Westgate Heights Park Addition, Unit 2 (File: M09D008B) RE: 8810 Sonya Ave. SW Grading Plan and Drainage Plan Engineer's Stamp Date – 12/010/2015

RE: WESTGATE HEIGHTS PARK ADDITION (M09d008B) – HYDROLOGY SUBMITTAL FOR BUILDING PERMIT REVIEW

RE: Westgate Heights Park Addition, Unit 2 (File: M09D008B) 8810 Sonya Ave. SW Grading Plan and Drainage Plan Engineer's Stamp Date – No Stamp

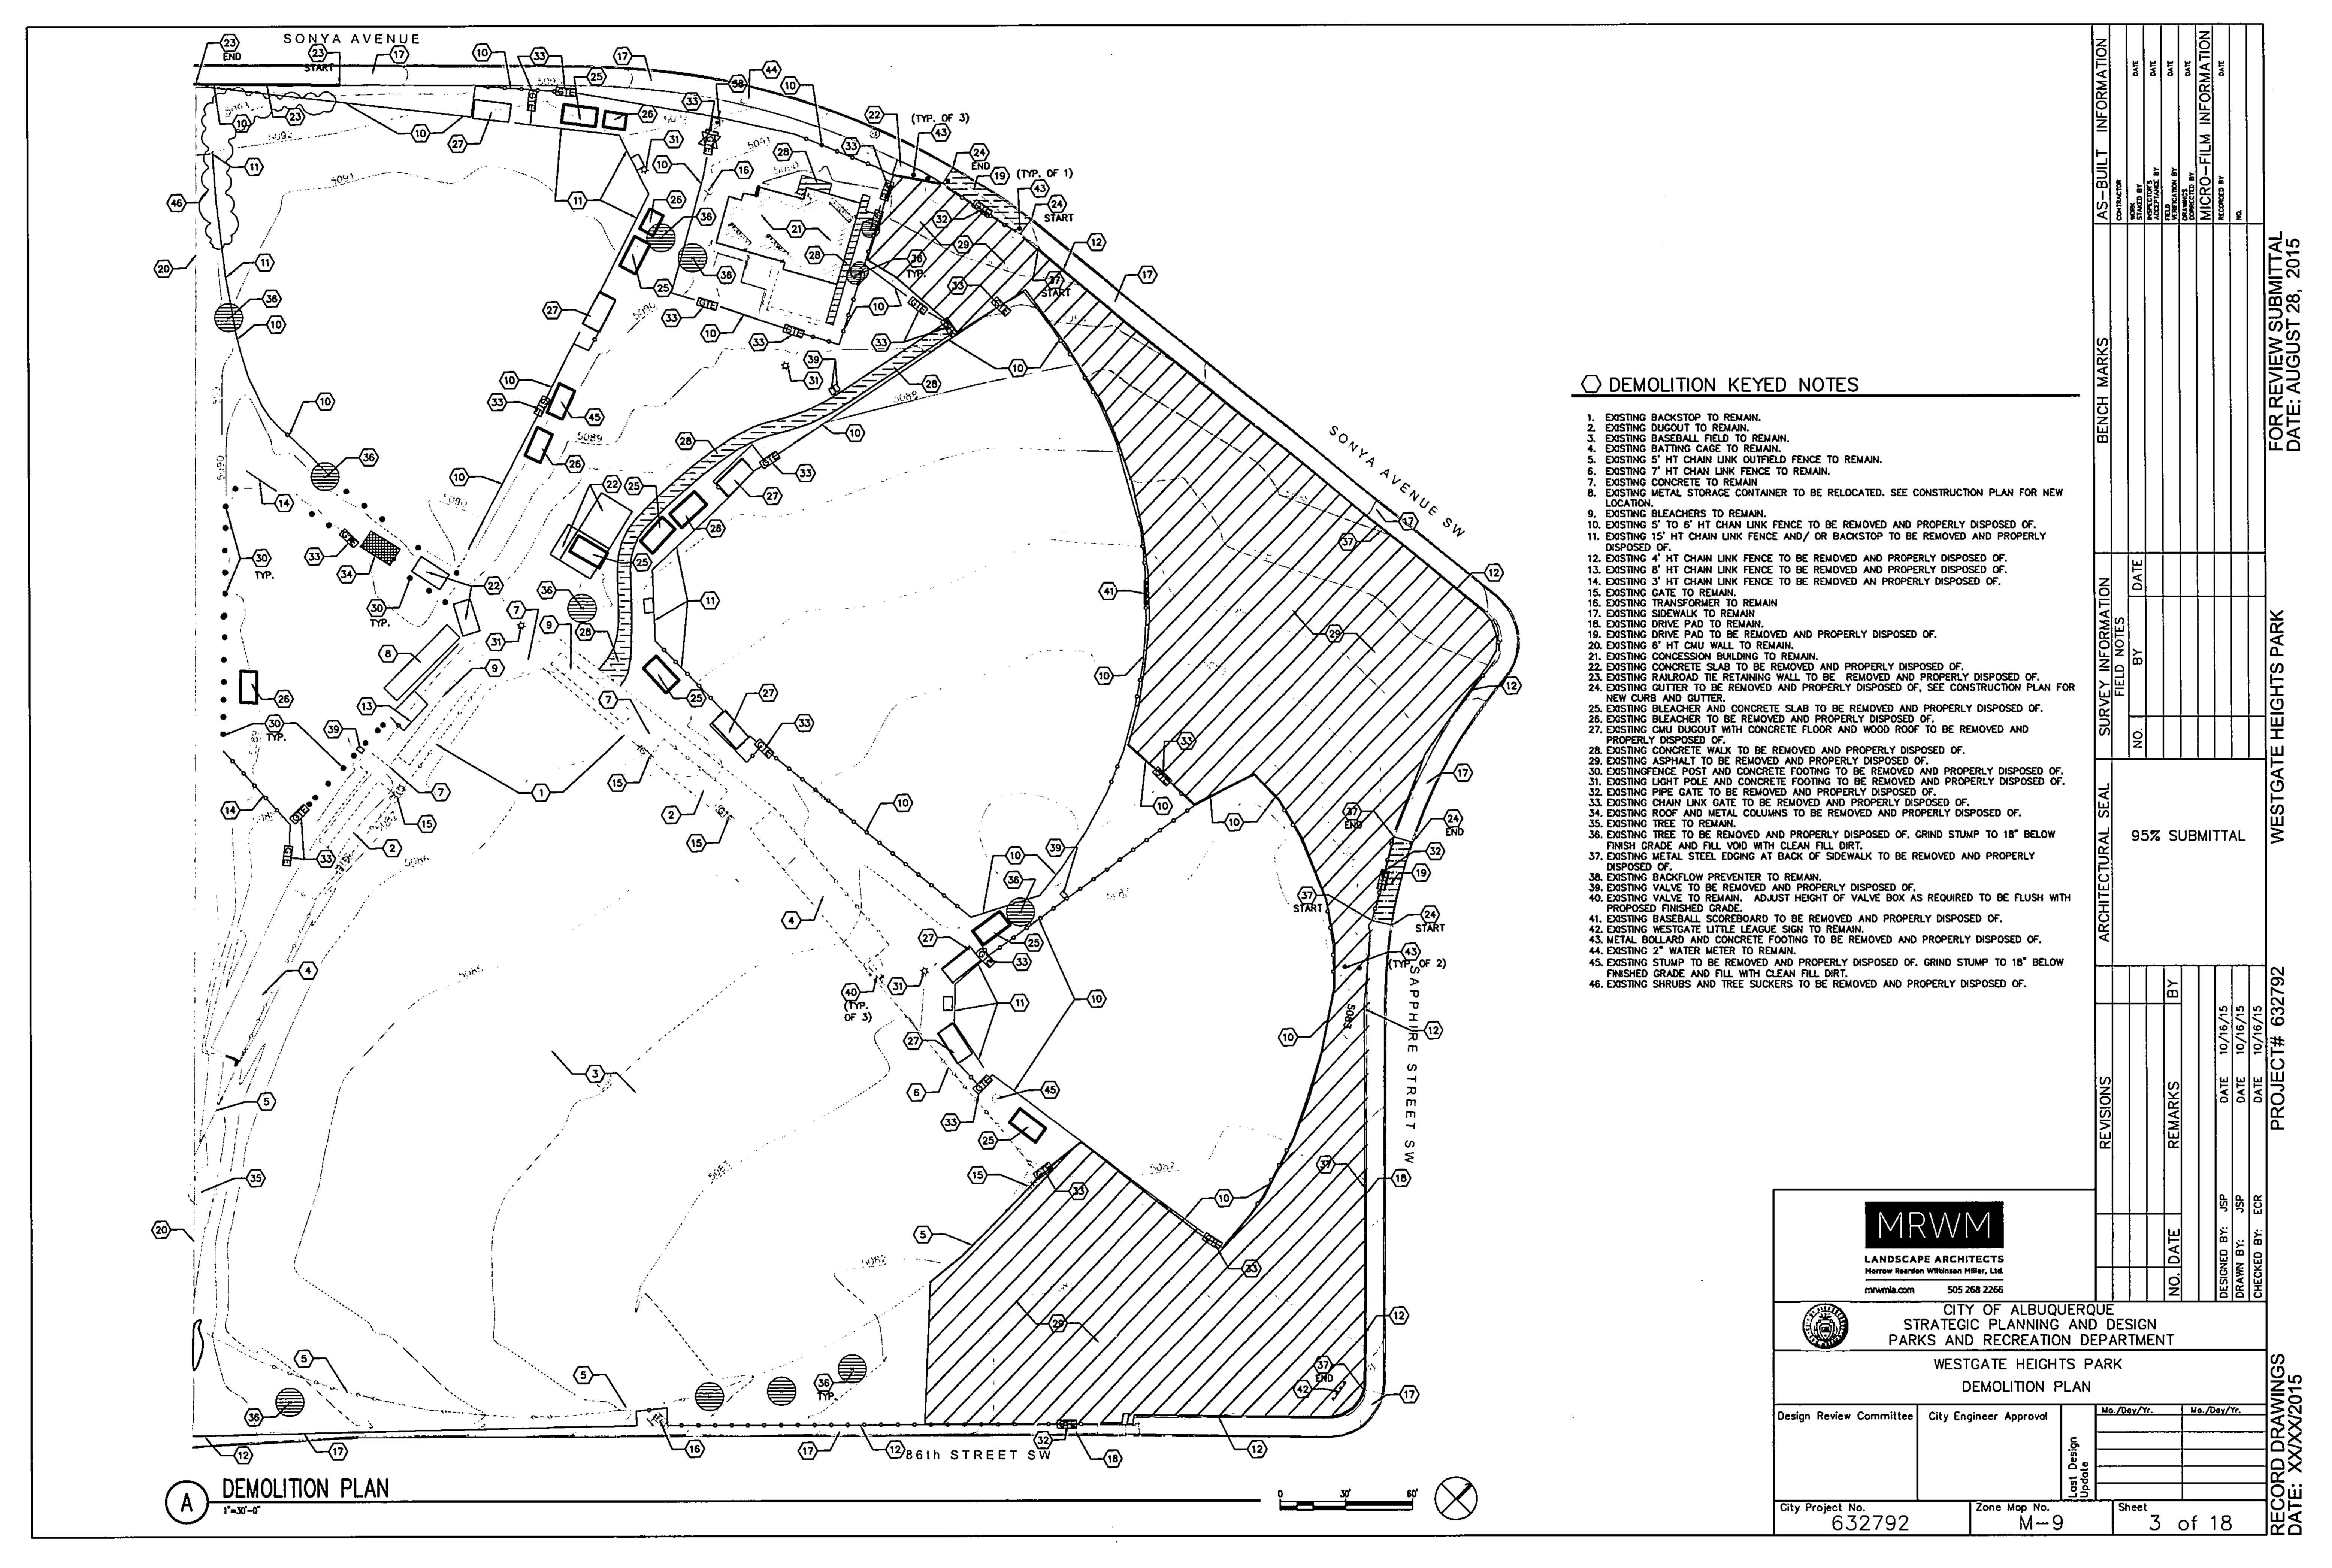
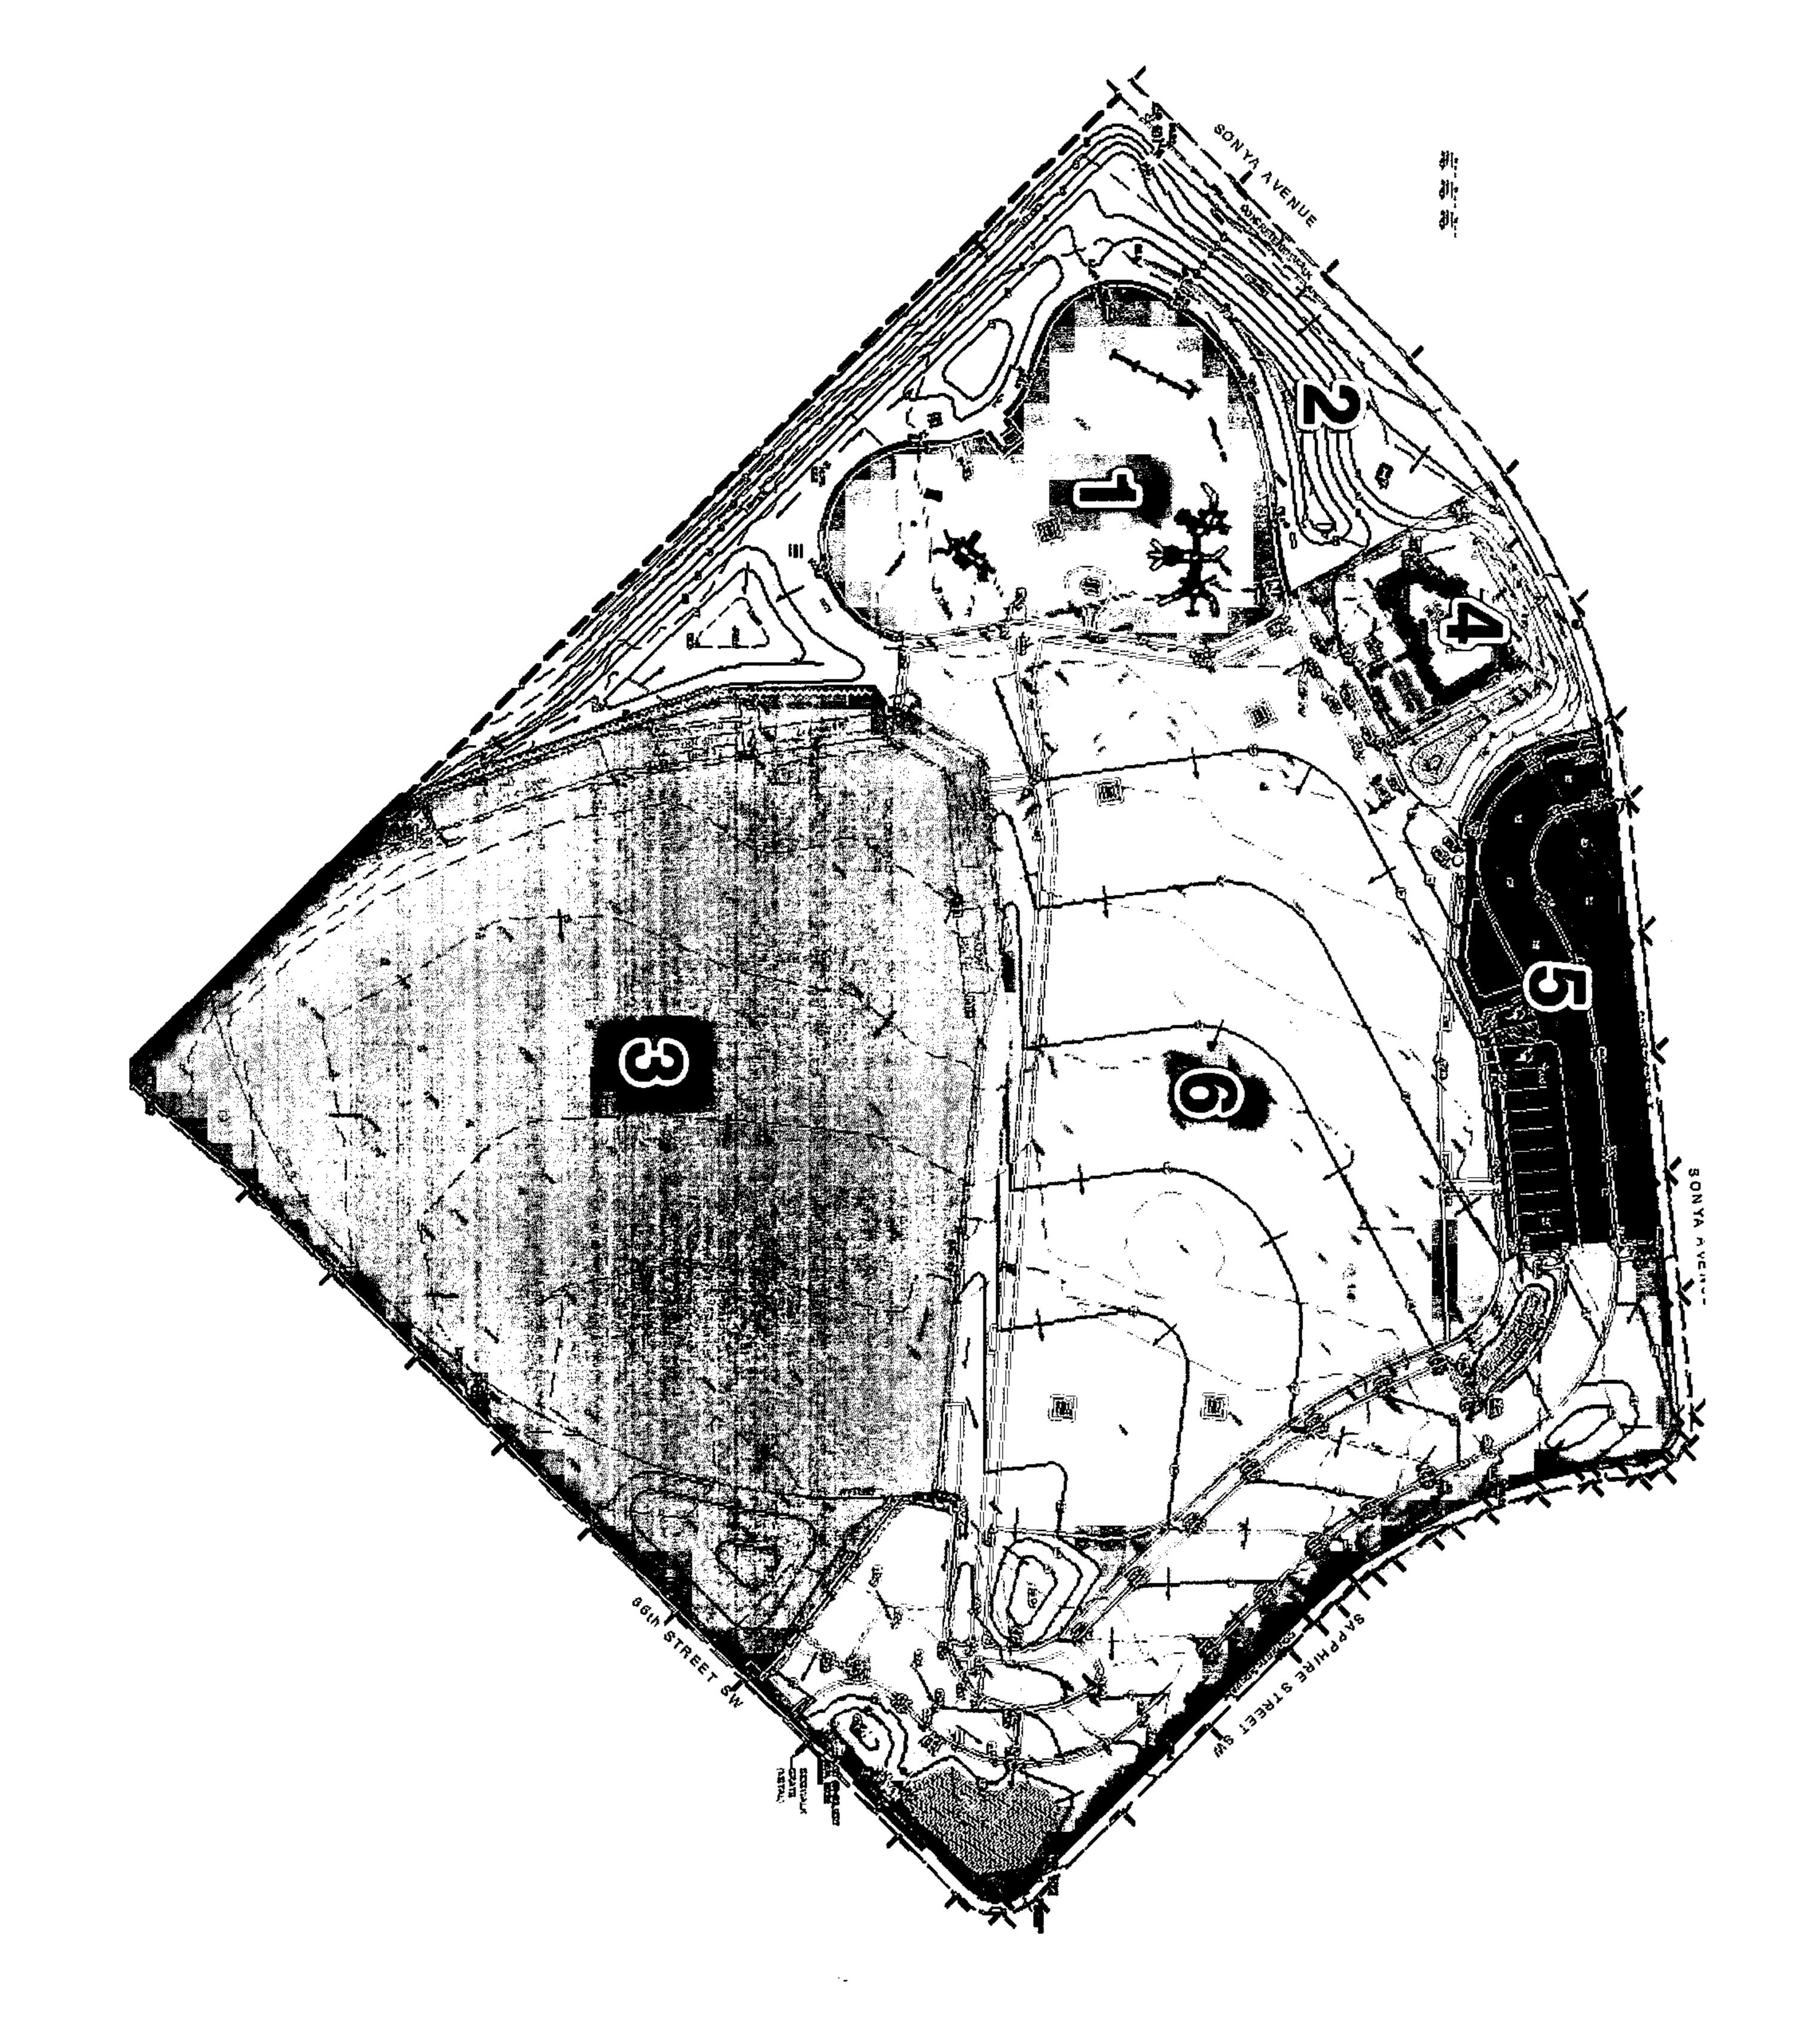
- Provide spot and contour elevations on the Overall Grading and Drainage Plan sheet.
- Provide flow line elevations at the outfall for each proposed sidewalk culvert onsite.
- The total area for historic flows does not match the total area for developed flows in the Calculation section of the Overall Grading and Drainage Plan sheet. Review this information to ensure the total basin area for existing and proposed conditions match.
- The area of land treatment D used in the First Flush calculation shown appears to be based on information provided in the previous submittal. Update the First Flush calculation on the Grading General Notes and Details sheet to reflect the changes to the area of land treatment D shown in the Calculation section of the Overall Grading and Drainage Plan sheet.
